PUBLIC INTEREST REVIEW FOR GROUND WATER APPLICATIONS

SUBJECT: Application G- 16482 Supersedes review of N/A
Date of Review(s)

A. GENERAL INFORMATION: Applicant's Name: Ashley Family Ranch County: Wasco

G-16482
12 WAS C 3651

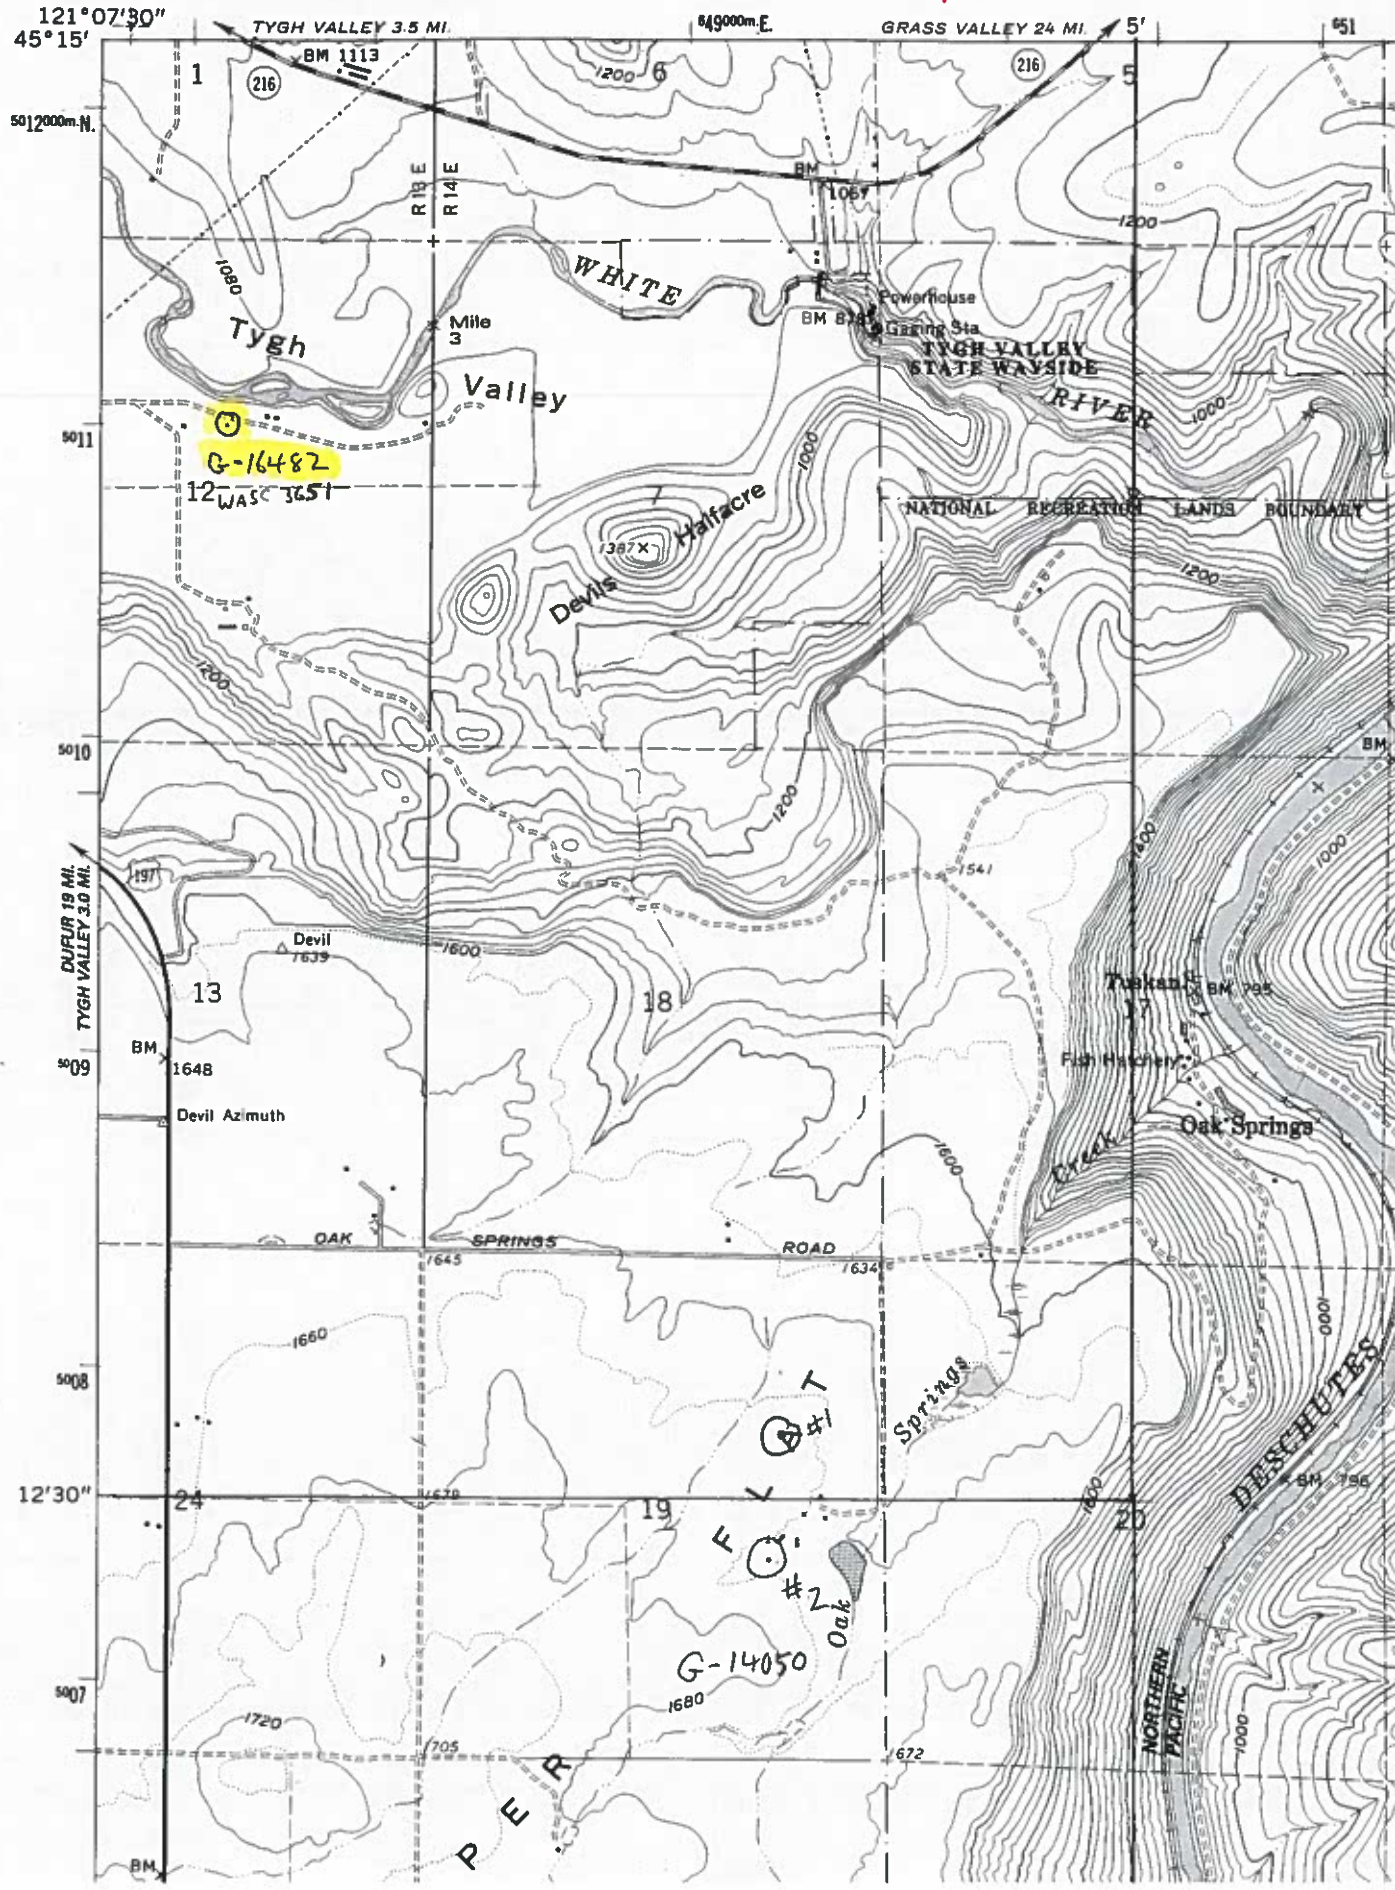
C6. SW / GW Remarks and Conditions This area is geologically complex and interesting. The alluvial deposits are quite limited areally and pinch out at the east end of Tygh Valley. The head in the subject well suggests poor local hydraulic connection, at least with the deeper gravels penetrated. The gradient of White River steepens considerably below the break in slope at the edge of the Deschutes canyon. Ground water in the alluvial deposits may provide recharge to underlying rocks of the Dalles Formation or Columbia River Basalt. These rocks are locally incised by the Deschutes River and lower reach of the White River. Therefore, hydraulic connection with the alluvium is likely to be indirect and interference diffuse with these reaches of the rivers, which are more than one mile from the well. I believe that use of the Hunt model is inappropriate.

- C5. If properly conditioned, the surface water source(s) can be adequately protected from interference, and/or ground water use under this permit can be regulated if it is found to substantially interfere with surface water:
 - i. The permit should contain condition #(s) 7J;
 - ii. The permit should contain special condition(s) as indicated in "Remarks" below;
